# ADDENDUM NO. 5

PROJECT: Computer Lab Expansion  
Blue Oak Elementary School  
2391 Merrychase Drive  
Cameron Park, CA 95682

Job No. 09-073  
DSA File Number No. 09-04  
DSA Application No. 02-111066

FROM: Placerville  
ANOVA Architects, Inc.  
778 Pacific St.  
Placerville, CA 95667

ESK-3

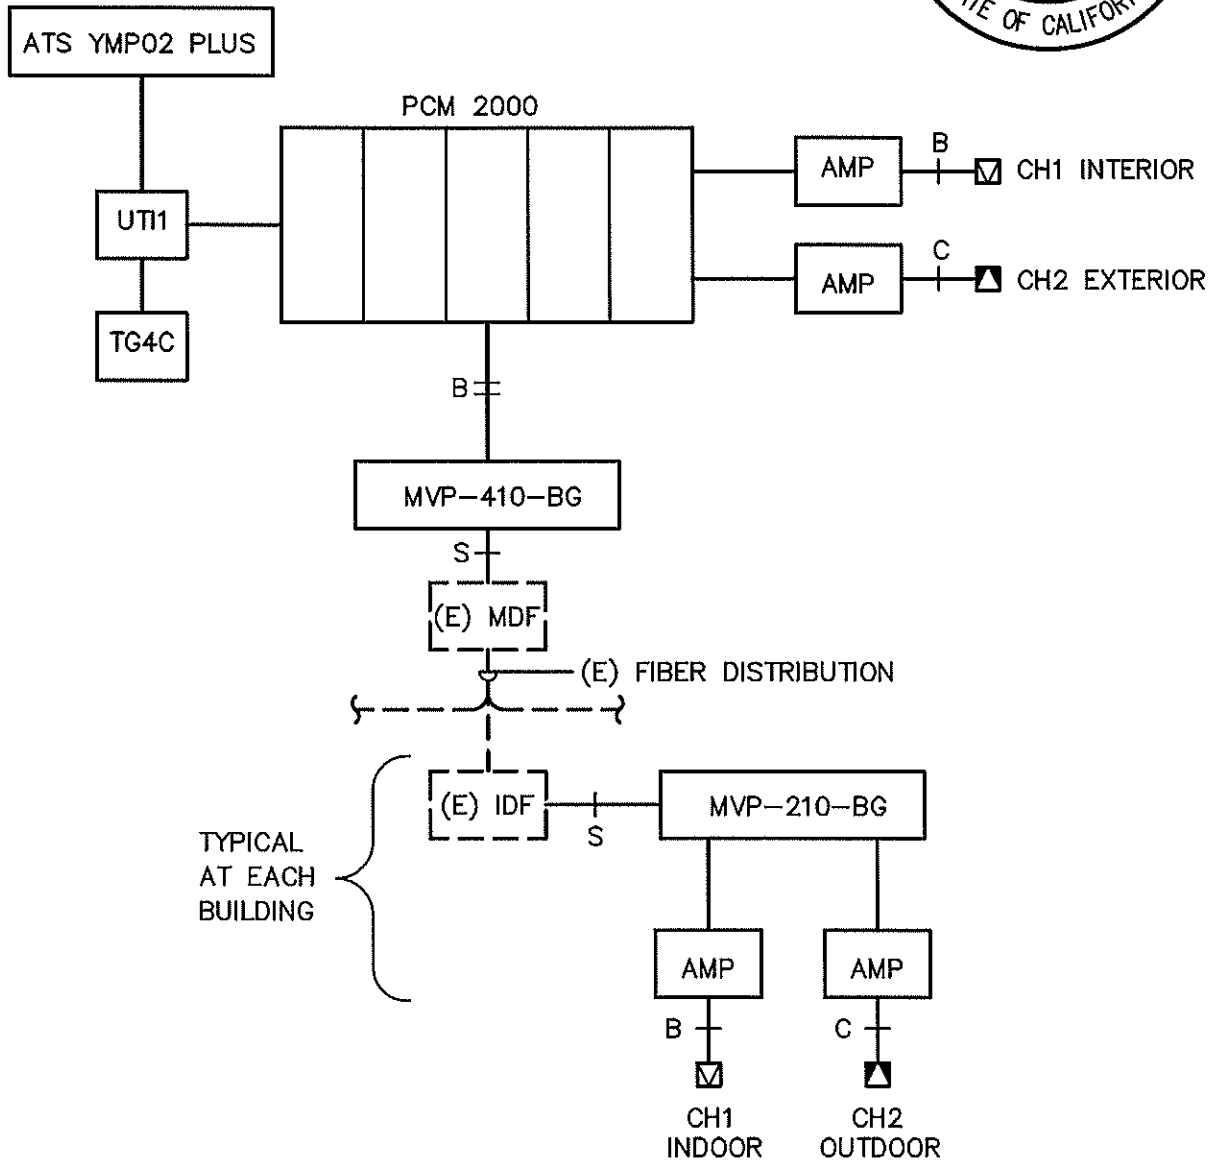
1. **Reference Addendum No. 3 and Specification Section 16730:**
  - a. REPLACE Section with new Section 16730 attached to this addendum.
2. **Reference Addendum No. 3 Item E4, revise as follows:**
  - a. DELETE items c. and d.
3. **Reference Addendum No. 3 Item E12, revise as follows:**
  - a. DELETE items d. and e.
4. **Reference Addendum No. 3, revise as follows:**
  - a. REPLACE 8-1/2" x 11" drawings ESK-1 and ESK-2 with 8-1/2" x 11" drawing ESK-3.

- J. **DATA NETWORK INTERFACE:** Provide conduit and data cable to existing MDF and IDF as shown on 8-1/2" x 11" drawing ESK-3. Connect to patch panel as directed by District IT person. Contractor shall program new system gateways and District IT will program existing network as required. Contractor shall work closely with District IT person to insure proper interface and operation.
